**Re: 4101 Paseo Del Norte NE - Sports Complex  
Request Permanent C.O. - Accepted  
Engineer's Stamp dated: 6/11/2015 (C17D008)  
Certification dated: 12-13-2017**

**SPORTSPLEX**  
fract A,  
loop industrial park  
Albuquerque, New Mexico

grading and  
drainage plan

date  
8-31-15  
sheet  
c102

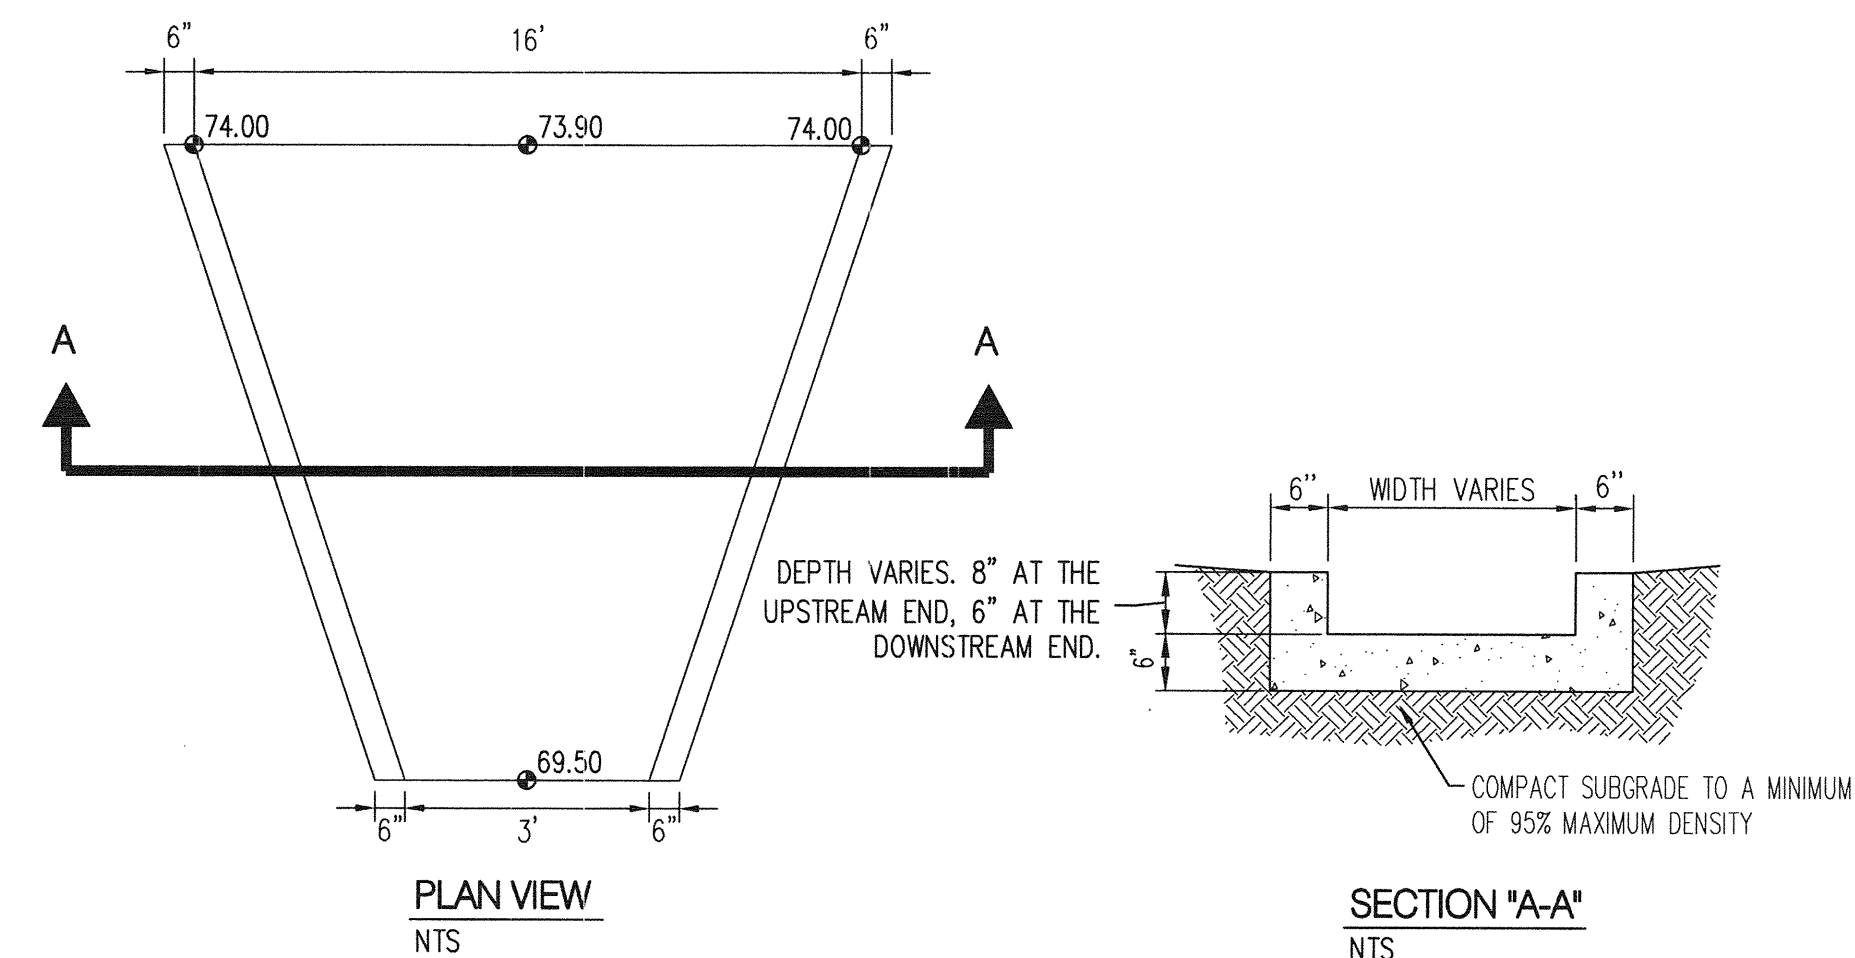
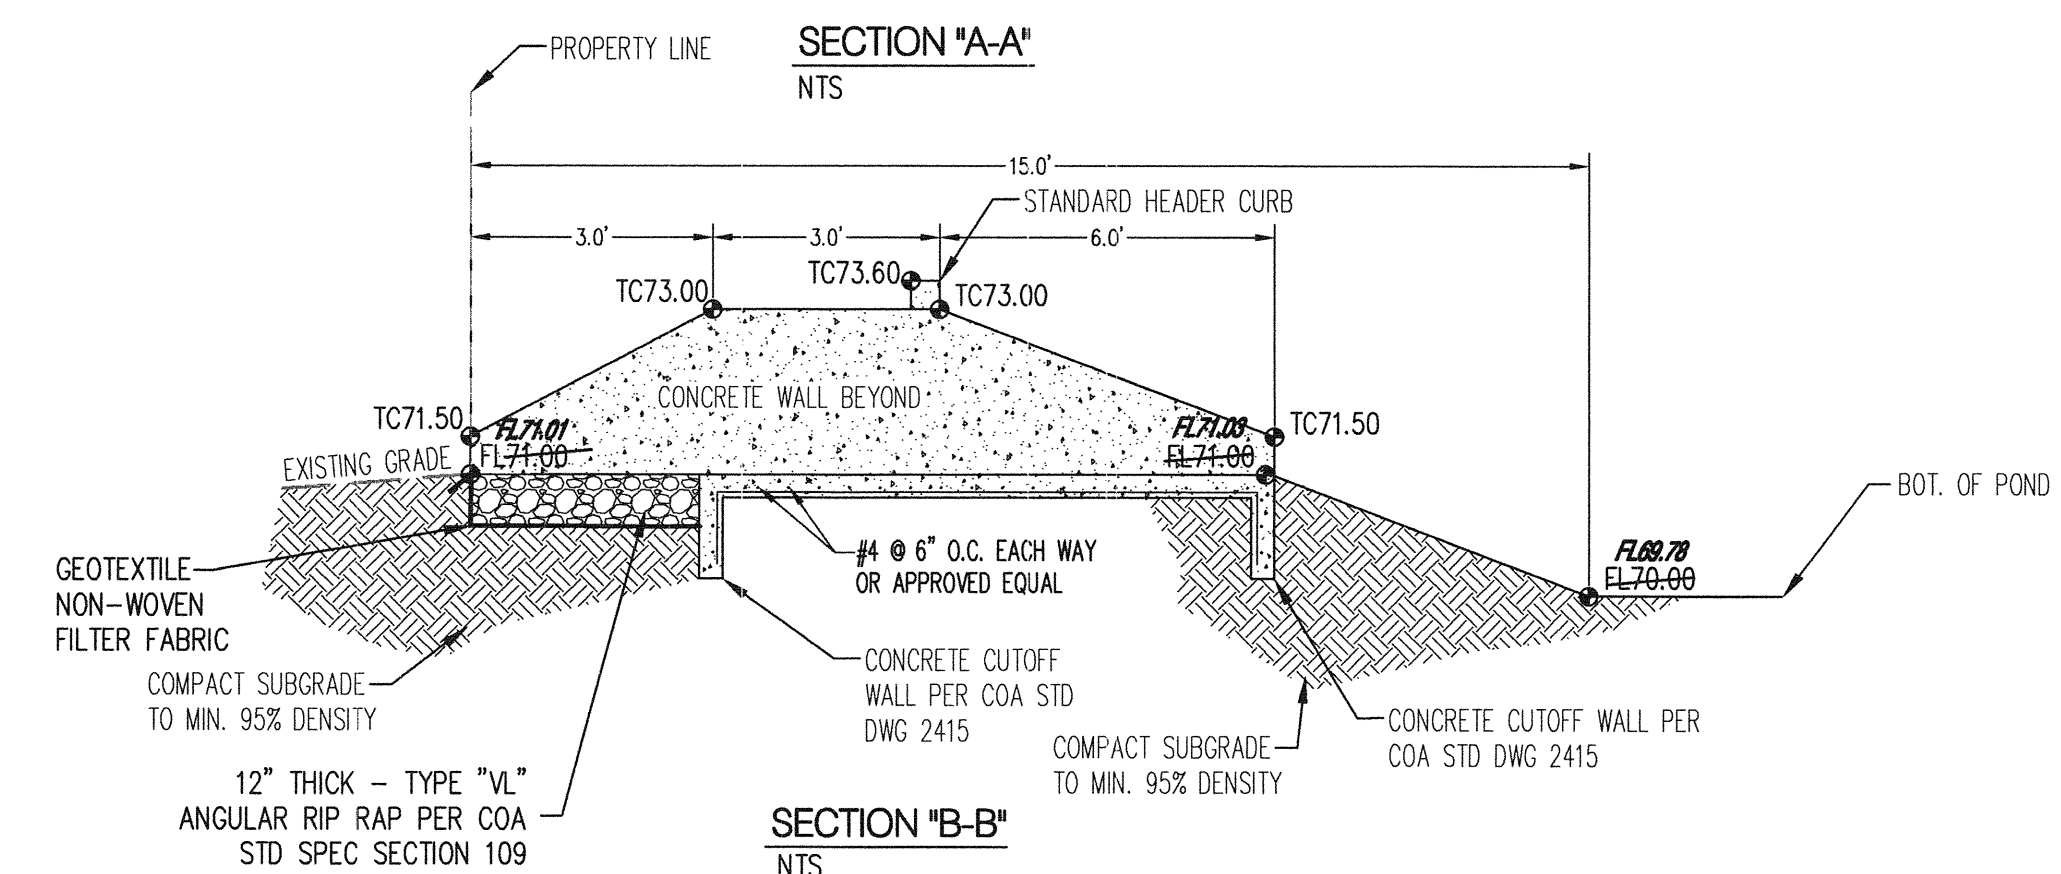
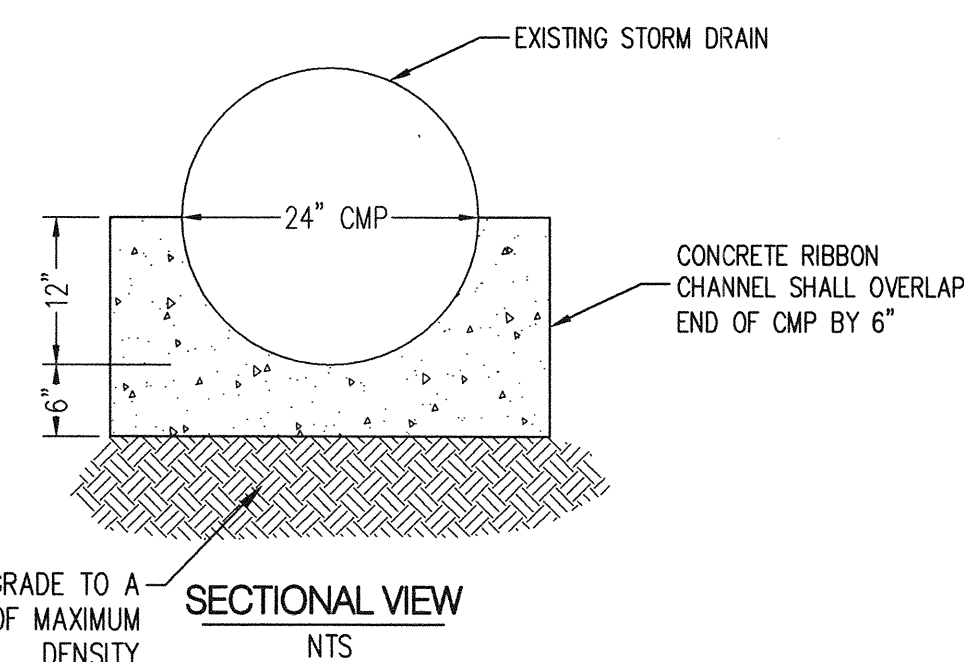
*DETAIL NO LONGER APPLICABLE*

POND AS CONSTRUCTED DOES NOT HAVE ADEQUATE FREEBOARD.  
CONTRACTOR TO MODIFY HEADER CURB TO MATCH DESIGN AND WILL BE  
MODIFIED PRIOR TO REQUESTING PERMANENT CERTIFICATE OF OCCUPANCY.
